15 October 2021

Our Ref: FP262

**IPART REVIEW OF CONTRIBUTIONS PLAN NO.18 – BELLA VISTA KELLYVILLE STATION PRECINCTS (FP262)**

Figure 1

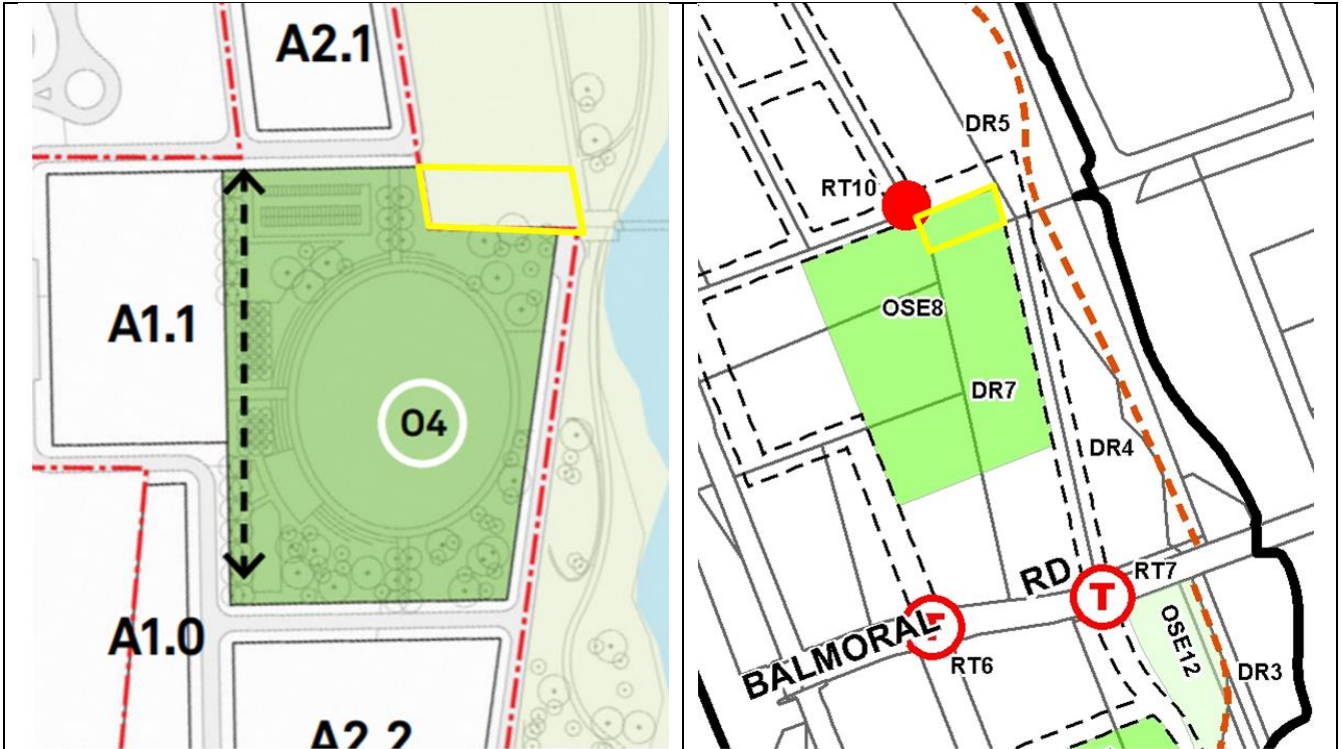
The draft Plan inadvertently excluded the cost for a portion of land required for the Bella Vista District Park. This small section to the north-east (indicated in the plans below) is under private ownership and not controlled by Landcom / Sydney Metro.

The draft Plan includes the capital cost for the entirety of the District Park (29.7ha). The draft Plan includes the cost of acquiring the 27.4ha of land owned by Sydney Metro, however inadvertently excluded the 0.23ha of private land which will ultimately form part of the District Park. Accordingly, it is requested that the land acquisition cost of this item be updated to reflect the correct area of the District Park as the areas used to calculate the land and capital costs should reflect each other.
